SERVICE BULLETIN No. 1097

COACH MODEL	: T2145, S2145 and C2045
BULLETIN TYPE	: Product Improvement
MANUAL & SECTION	: Maintenance Manual: Chapter 9-Electrical System Spare Parts Manual: Section 783509-Electrical Equipment
PARTS BOOK REVISION	: Yes
DATE	: January 10th, 2002
SUBJECT	: Automatic fire alarm - heat sensors
TERMS & CONDITIONS	: Parts and labor allowance will be provided as per warranty information in this Bulletin.

Figure 1: Heat sensor approximate size

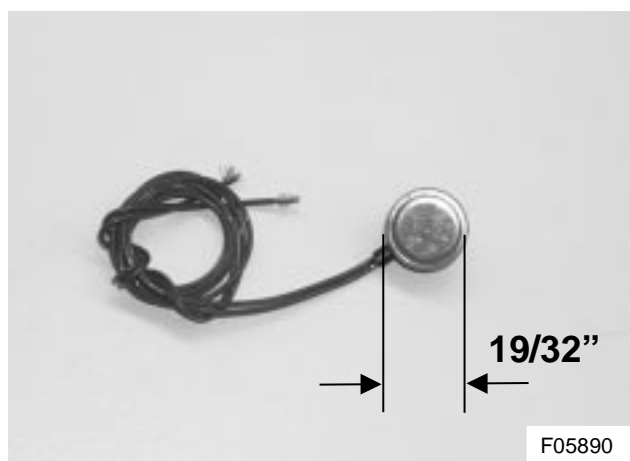
The trigger point of the heat sensors in the engine and combustion heater compartments has been increased from 230°F (110°C ± 3°C) to 300°F (150°C ± 5°C). Because of this specification change, heat sensor VH 106391085 has been replaced in production by heat sensor VH 10766487.

Part No.	Description	Qty.
VH 10766487	Heat sensor, 300F (150°C)	3

Figure 2: Heat sensor markings

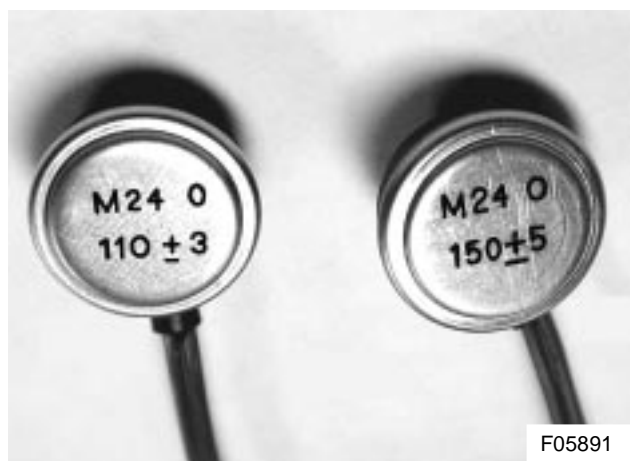
- Old and new parts are interchangeable, but only the new will be offered for service replacement.
- Part VH 10639105 has been marked: "M24 0 110 ± 3".
- Part VH 10766487 has been marked: "M24 0 150 ± 5".
- Parts may be purchased from your nearest International Coach Parts Inc. dealer.
- Always use genuine maintenance products and parts. Do not accept imitations.
